Final Focused Feasibility Study Report
Ground Water Remediation

Shieldalloy Metallurgical Corporation
Newfield, New Jersey

Prepared by:
TRC Environmental Corporation

April 1993
Revision 1: June 1993
Revision 2: February 1994

SITE LOCATION MAP

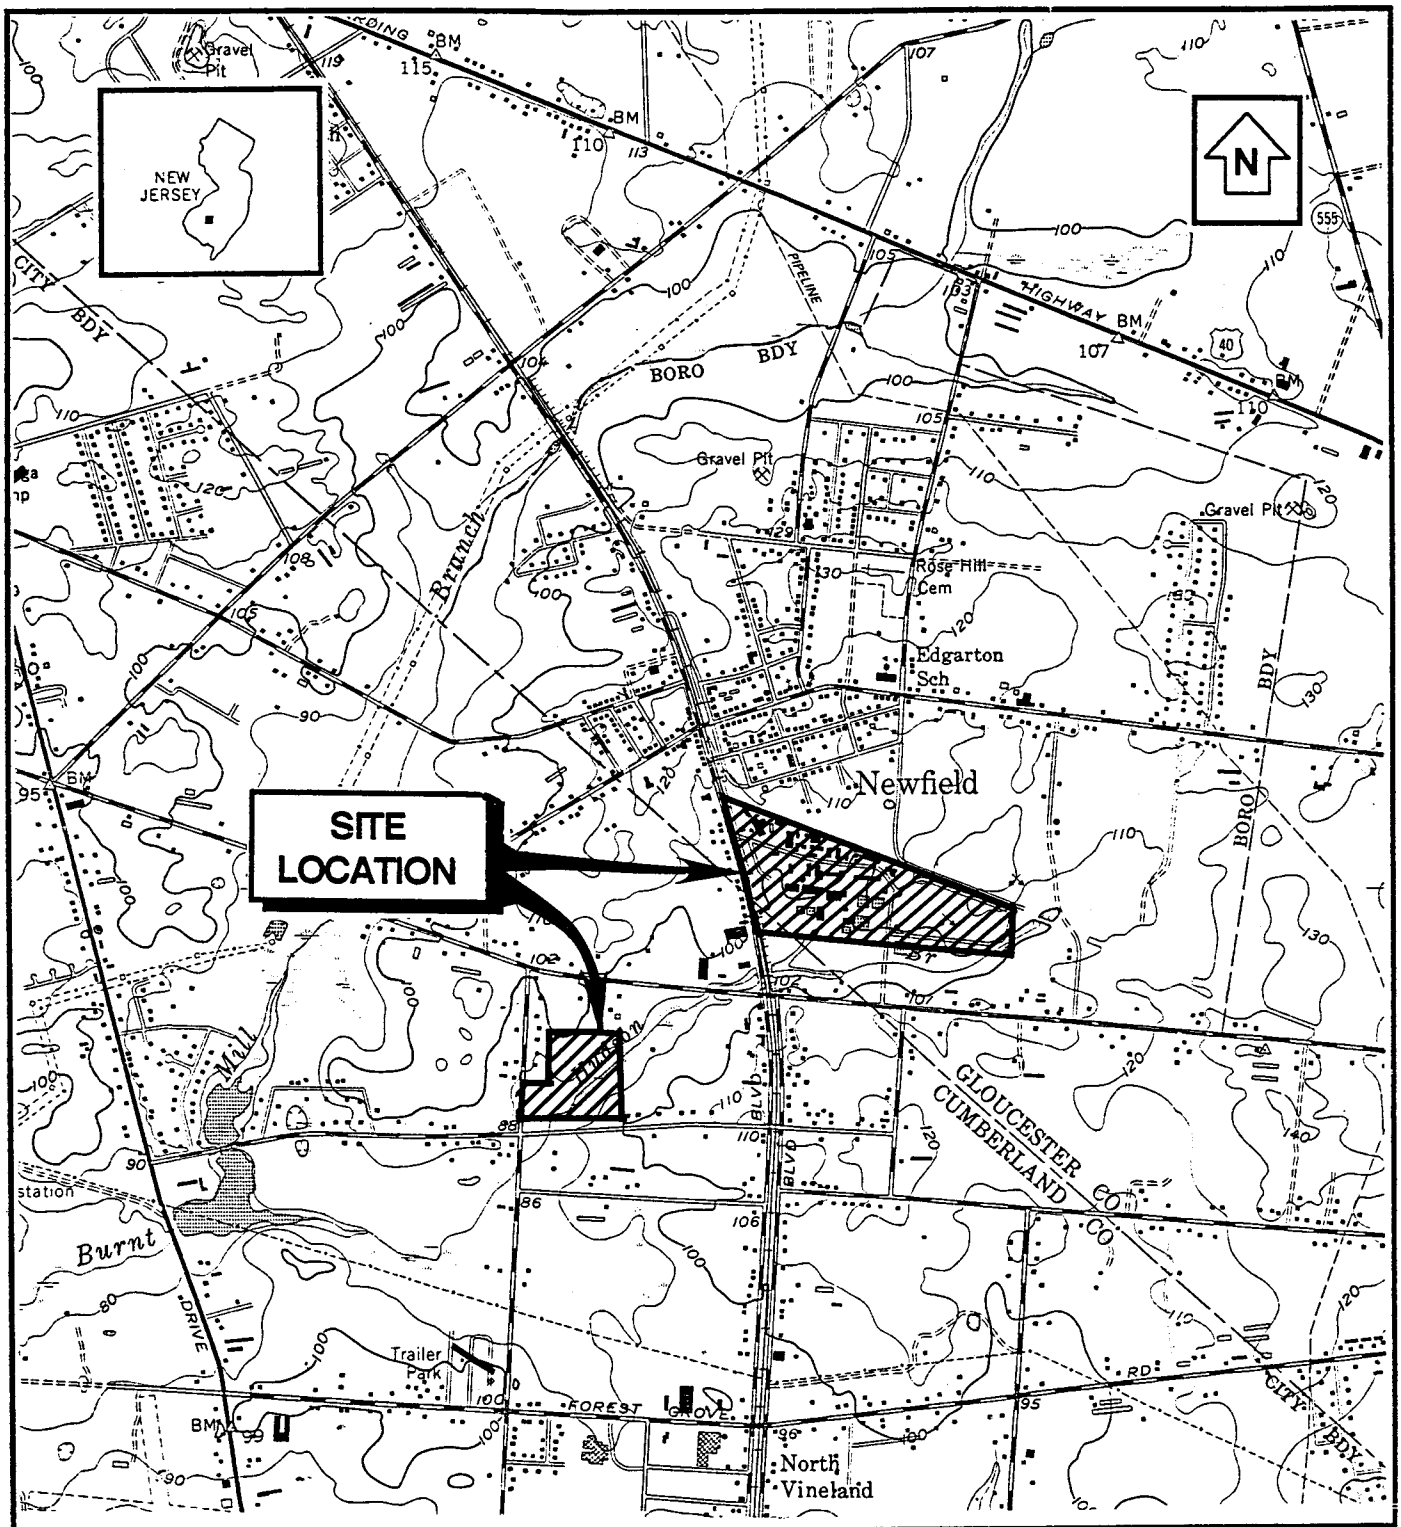
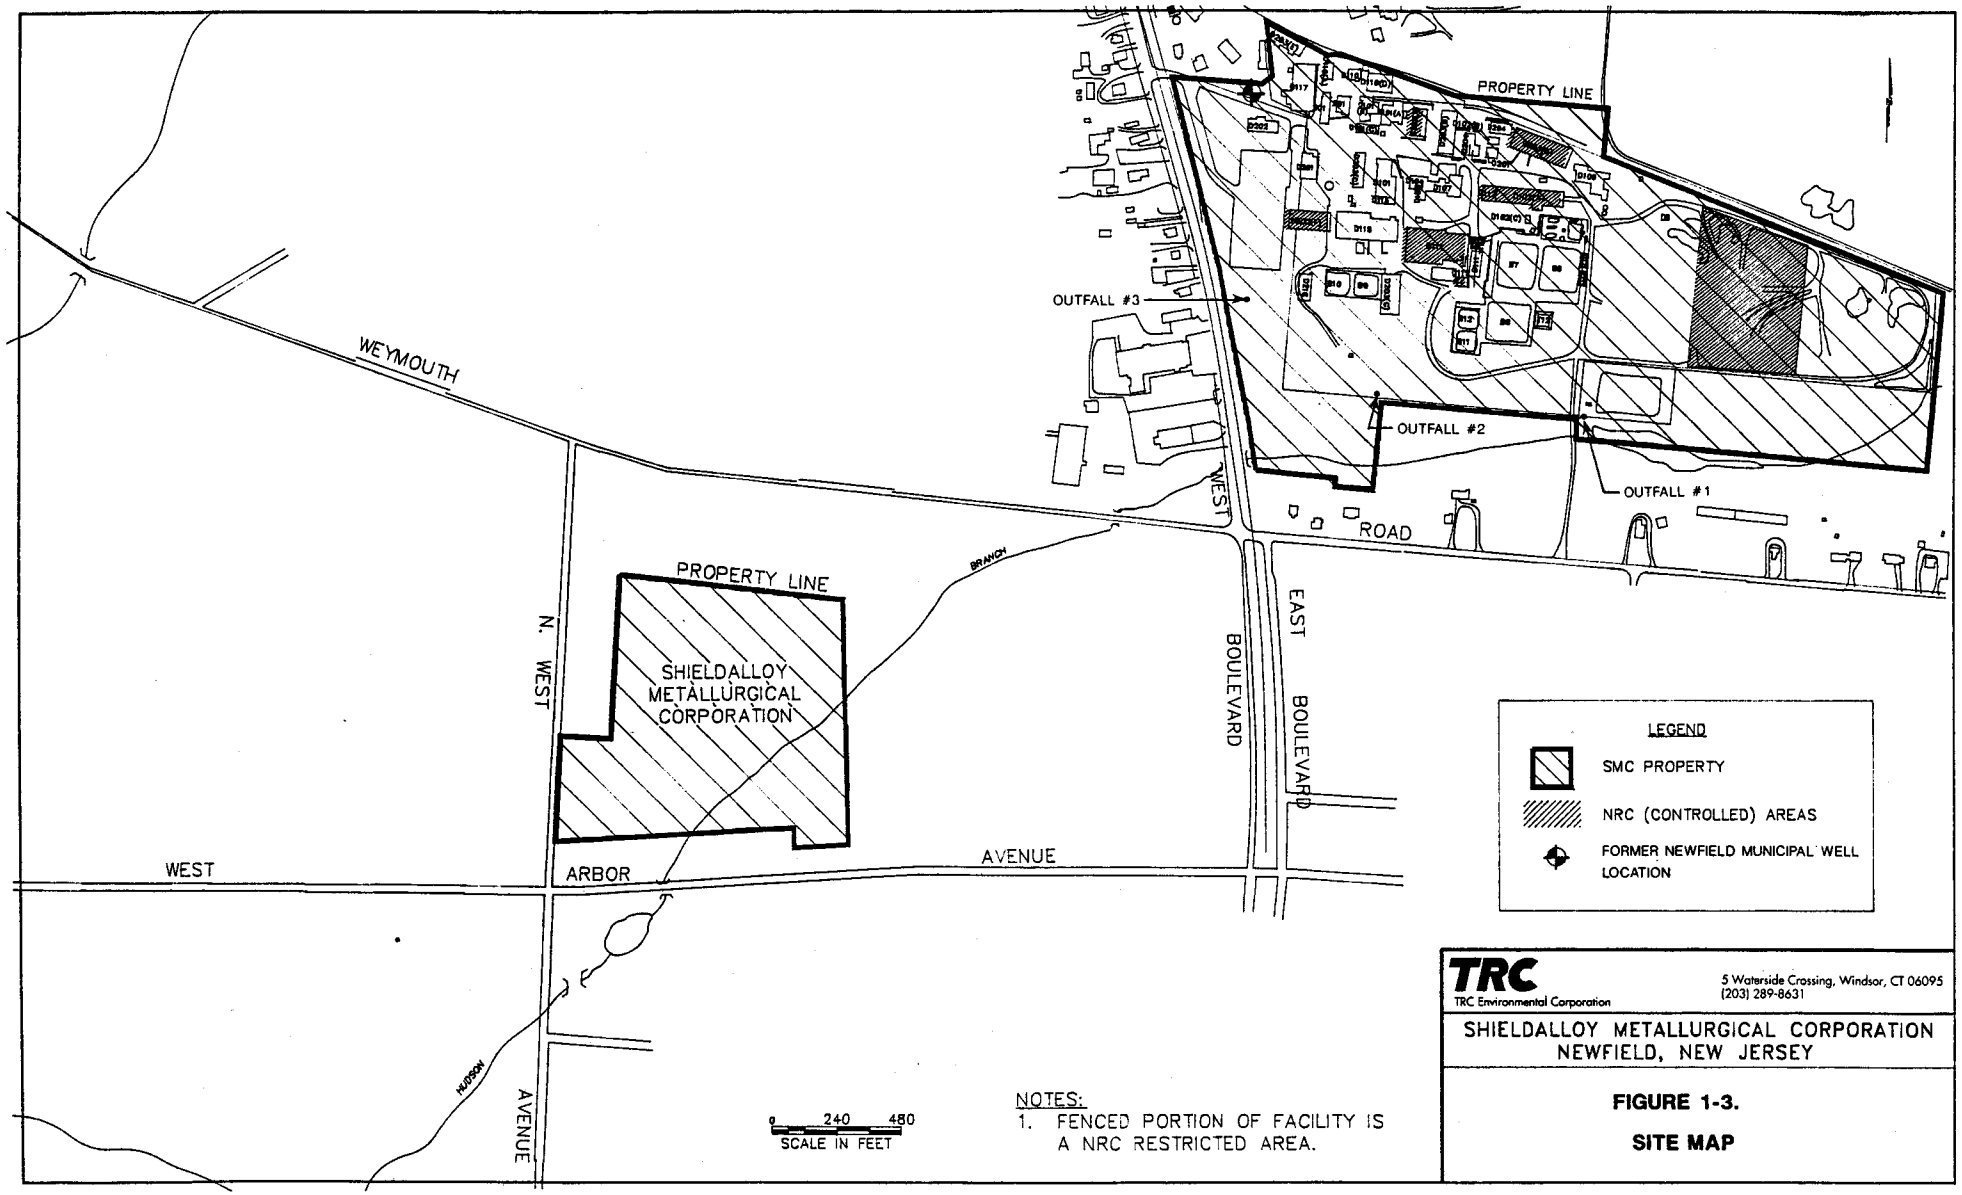
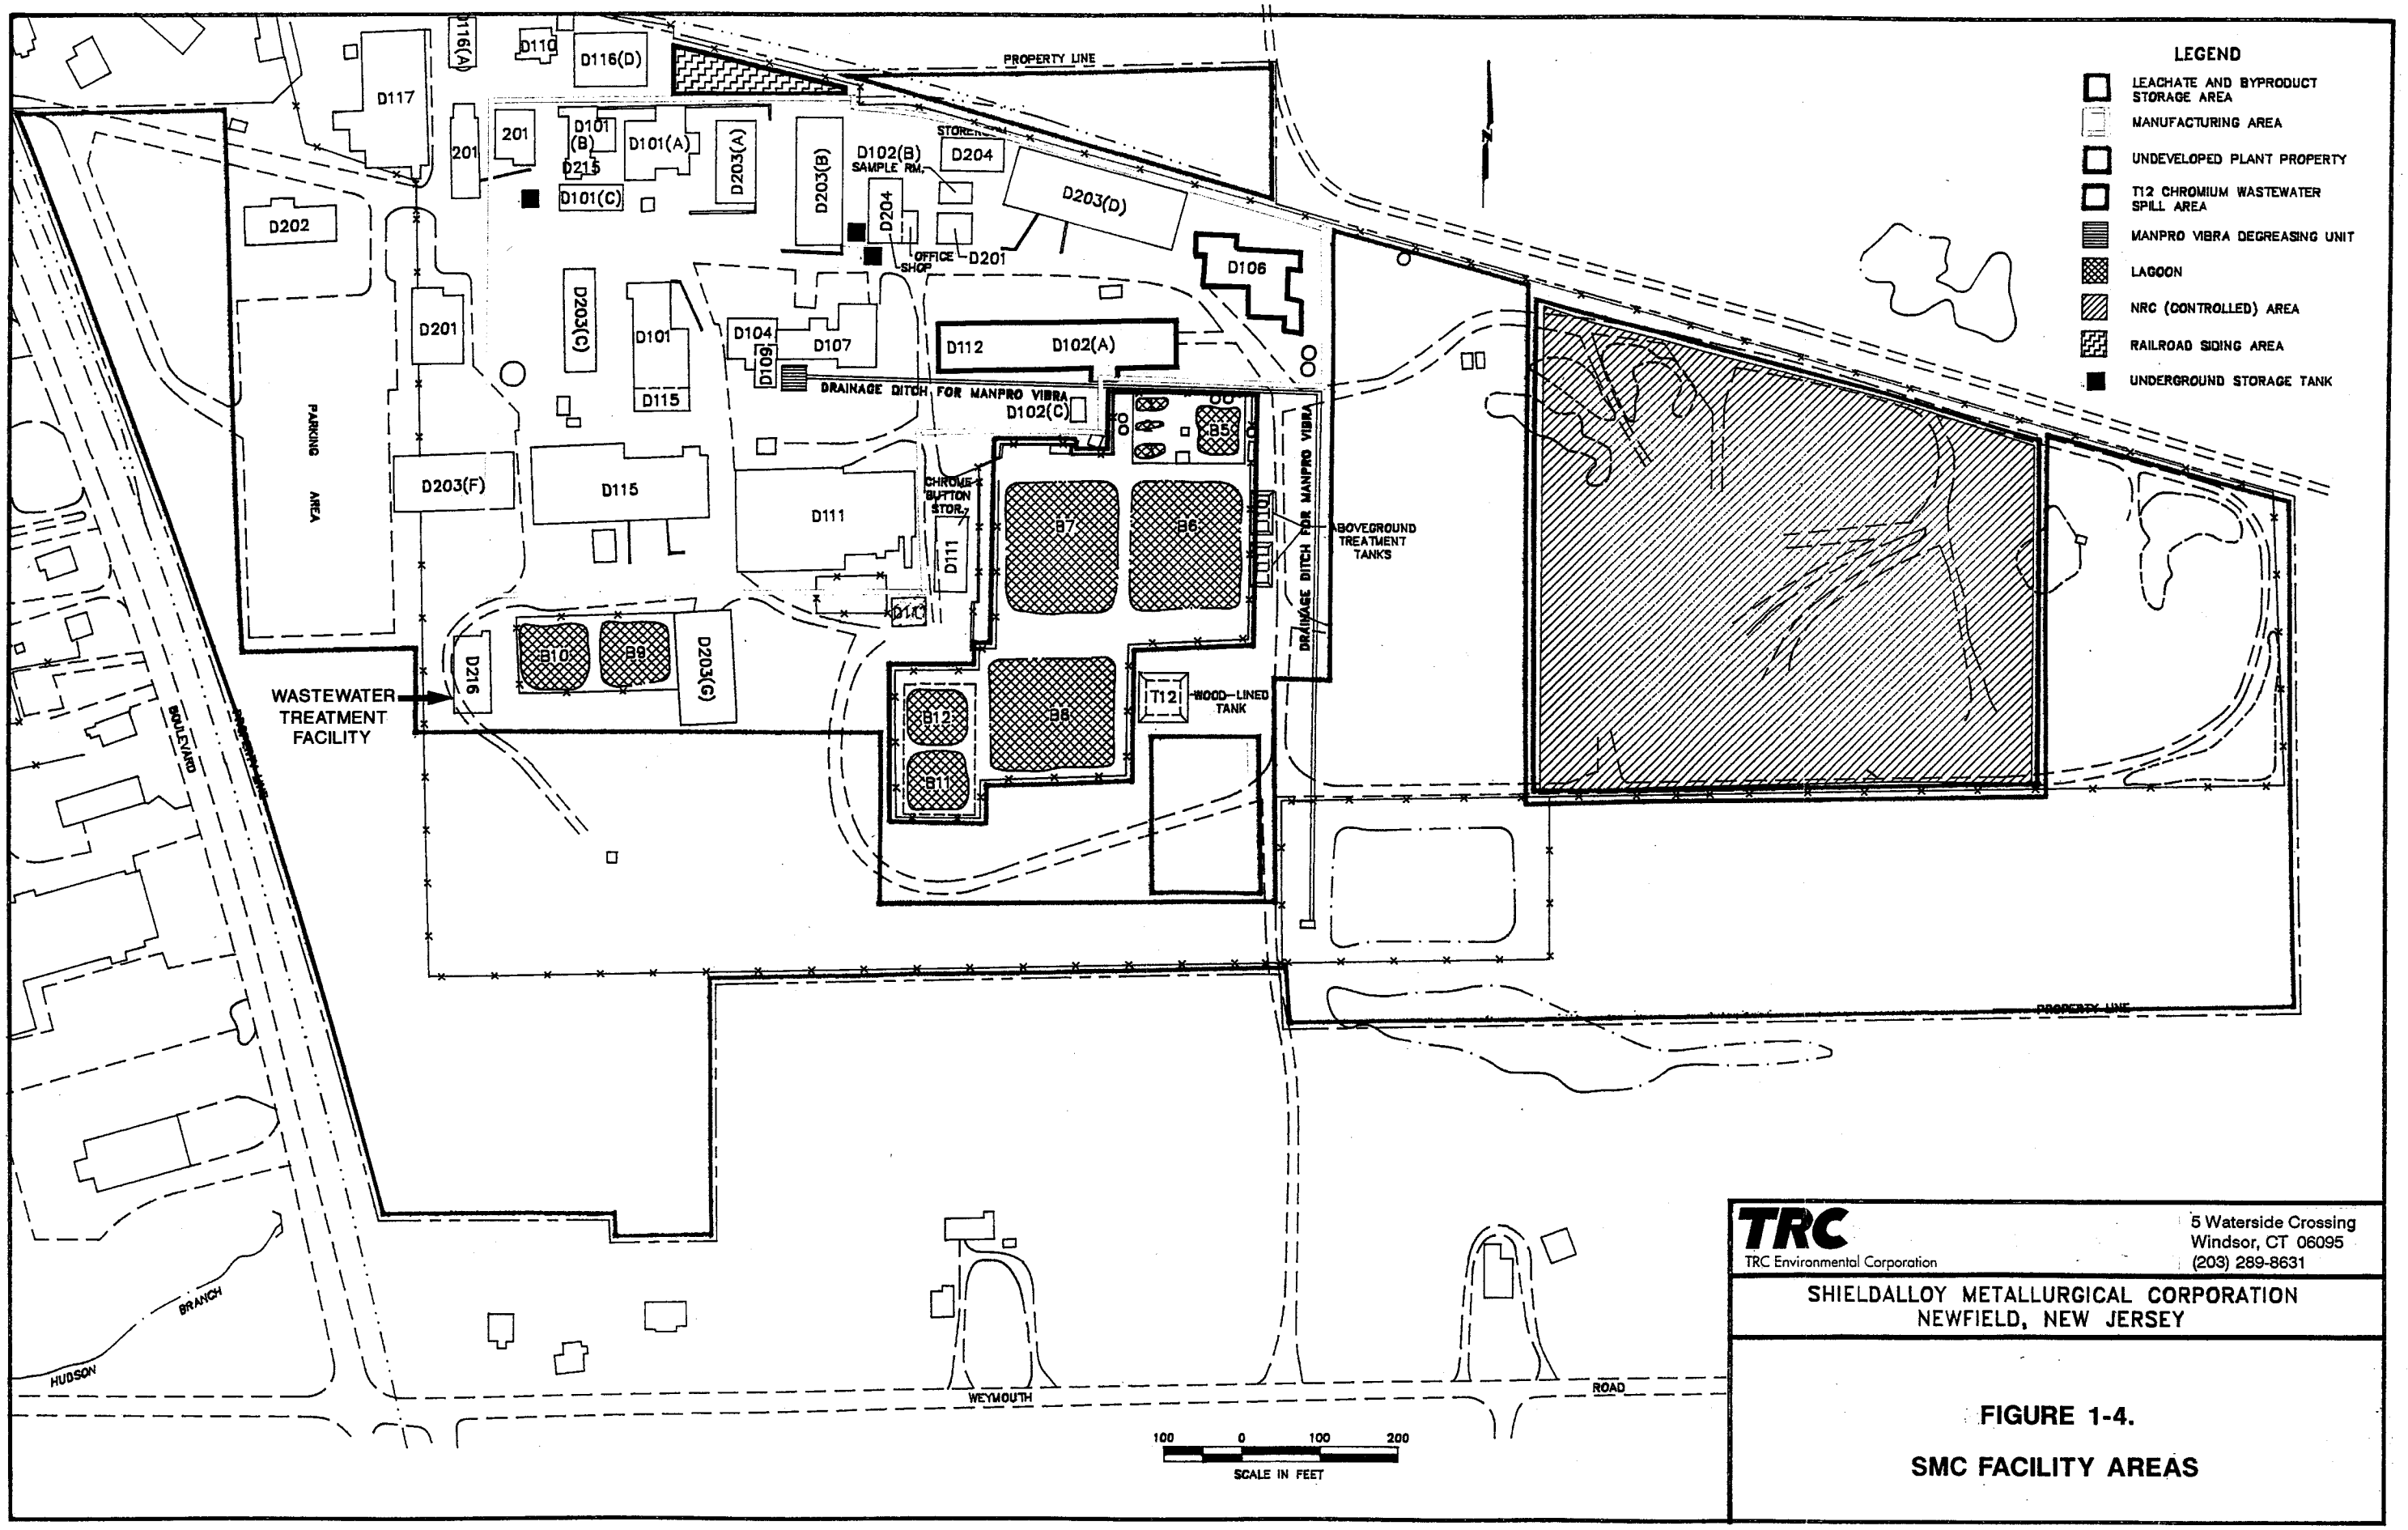
This section describes a 2-acre parcel of SMC-owned property along Weymouth Road in Newfield and shows the location on Figure 5-11. This SMC-owned property shall also be shown of Figures 1-2, 1-3 and 1-4 at a minimum.

Response: *The general location of this parcel is shown on Figure 5-11. However, this parcel has historically been limited to residential use and is not pertinent to the overall RI/FS investigation of the SMC facility. Therefore, its location is not shown on Figures 1-2, 1-3 and 1-4.*
